Application Note ANBS1.00.03 [Issued date November 15, 2008]

LCD driver migrating from ILI9320 to ILI9325

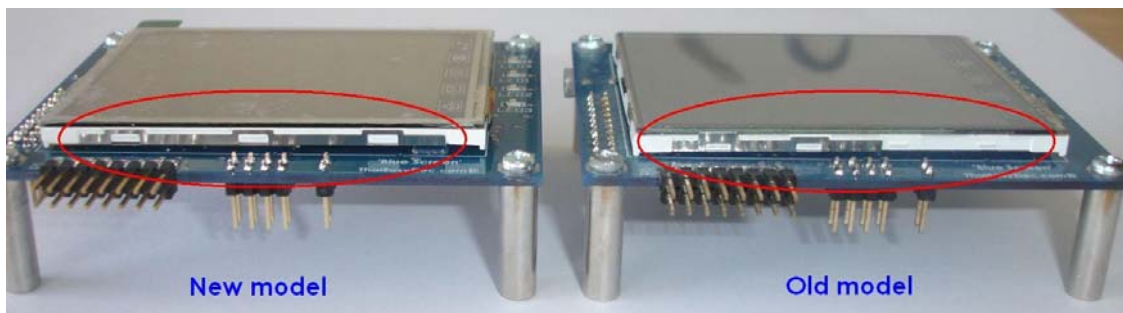
Since November 2008, the LCD installed on Blue Screen has been changed from model ELT240320TP to model ELT240320ATP. To identify a model, see picture below.
